UNITED STATES PATENT AND TRADEMARK OFFICE

APPLICATION NO.	FILING DATE	FIRST NAMED INVENTOR	ATTORNEY DOCKET NO.	CONFIRMATION NO.
10/591,627	09/05/2006	Franz Schwendemann	15407.0001USWO	3314

Office Action Summary	Application No. 10/591,627	Applicant(s) SCHWENDEMANN, FRANZ	
	Examiner DANIEL YABUT	Art Unit 3656

DETAILED ACTION

Figure Y: View of supporting member within rotor drive in the device of Frey et a

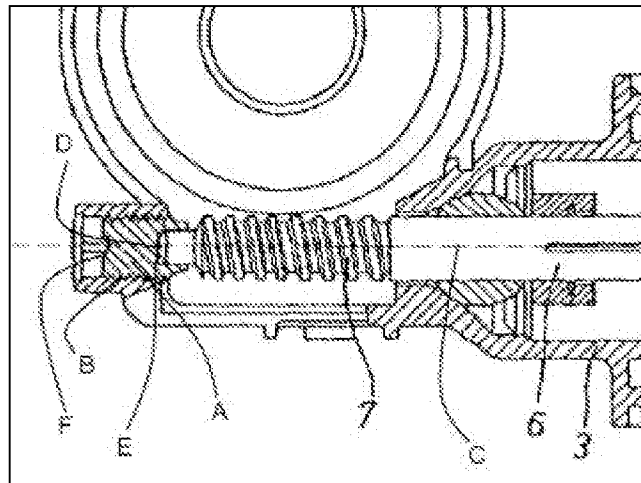
- Rotor (6) positioned with bearings (see bearings near 6 and 14 in Fig. 1) in a housing (Fig. 1) the housing defining a bore
- Supporting member (A; see Figure Y below) that provides an axial force to support the rotor, the supporting member including a(n):
- Base having a longitudinal axis (near F; Fig. Y below)
- Plurality of individual crosspieces (§ [0029] ll. 8-10)

- Rotor has a front face with a radius (D; see Fig. Y below) that rests against a flat stop surface (E; see Fig. Y below) that is formed on the supporting member

- Supporting member has a first end and a second end, the first end including a stop face that contacts the rotor (at E; Fig. Y below), the second having a form closed entrainment member (F; see Figure Y below; see ¶ [0029] lines 8-14)

- Rotor (6) positioned with bearings (see bearings near 6 and 14 in Fig. 1) in the housing (Fig. 1)
- Supporting member (34), which is attached via a form closure (at F; Fig.Y below) on the housing

- Supporting member (A; see Figure Y below) that provides an axial force to support the rotor having radial crosspieces (see ¶ [0029], lines 8-10) having a shape that is complementary to a shape of the recesses such that the crosspieces axially insert within the recesses during installation without turning (col. 5 ll. 39-51; Antonucci).

- Supporting member includes a base (at F; Fig. Y below), and wherein the crosspieces are spaced apart from one another about an outer diameter of the base (28; Fig. 8; Antonucci)
